Statement of Common Ground between Hornsea Project Three  
(UK) Ltd. and Highways England

Date: March 2019

## Appendix A - Applicant's Response to Highways England Briefing Note 01A

Project:	<b>Highways England Spatial Planning Arrangement 2016-2020</b>	Job No:	<b>60506522 / DN055.002</b>
Subject:	<b>Hornsea Project Three Offshore Wind Farm – Impact on the A47/ Taverham Road junction at Honingham</b>		
Prepared by:	<b>Andrew Cuthbert</b>	Date:	<b>16<sup>th</sup> November 2018</b>
Checked by:	<b>Andrew Beard</b>	Date:	<b>19<sup>th</sup> November 2018</b>
Verified by:	<b>John Alderman</b>	Date:	<b>19<sup>th</sup> November 2018</b>
Approved by:	<b>Andrew Cuthbert</b>	Date:	<b>19<sup>th</sup> November 2018</b>

**Figure 2.1 – Crashmap A47/Taverham Road Junction Assessment**

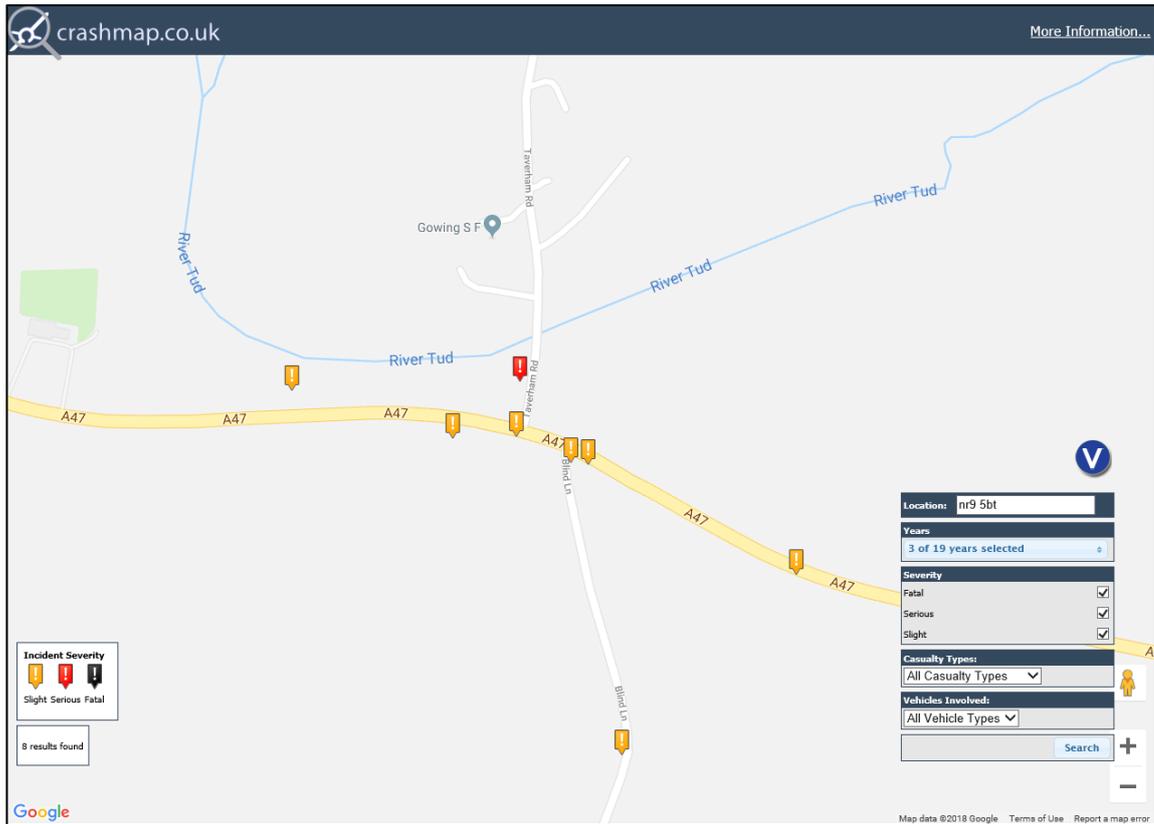
- 4.24 To address the AECOM concerns regarding the A47/Taverham Road junction a review of road safety has been carried out using the “Crashmap” recorded personal injury accident database. The review includes three years of accident data to the end of 2017 as shown in Figure 2.1 below:

- 4.25 The Crashmap data depicted in Figure 2.1 shows that only one accident occurred on the A47 immediately adjacent to the Taverham Road junction. This accident is classified as ‘Slight’ in severity and was recorded on the 15 January 2016 involving two vehicles resulting in one casualty.

- 4.26 Figure 2.1 also shows an accident recorded on Taverham Road approximately 35m north of the junction with the A47. This accident occurred on 26 July 2017 and is classified as ‘Serious’ in severity involving two vehicles and one casualty.

- 4.27 The next closest accident to the A47/Taverham Road junction was recorded on 4 May 2018, approximately 50m to the west on the A47. This incident was classified as ‘Slight’ in severity involving two vehicles and two casualties.

- 4.28 The two accidents shown to the east of Taverham Road along the A47 are more closely linked to the Blind Lane junction to the south and therefore are not relevant to this assessment.

5. **Paragraphs 2.20 – 2.24** and **Figure 2.1** of the RN suggest that a total of eight PIAs were recorded across the study area from the information provided by crashmap.co.uk, with seven resulting in slight injuries and one in serious injuries. No PIAs recorded within the last three years (up to the end of 2017) resulted in a fatality. AECOM have undertaken an independent review using Crashmap and note that a total of ten collisions were recorded across the study area during the study period. Therefore, two collisions, recorded as slight in severity, have been omitted, bringing

the total collisions in the study area to ten over the three year period. One of these collisions occurred approximately 35m west of the A47/ Taverham Rd junction and the other at the junction of A47/ Blind Lane. Given the RN is dated November 2018, there doesn't appear to be a logical explanation as to why these two collisions have been omitted.
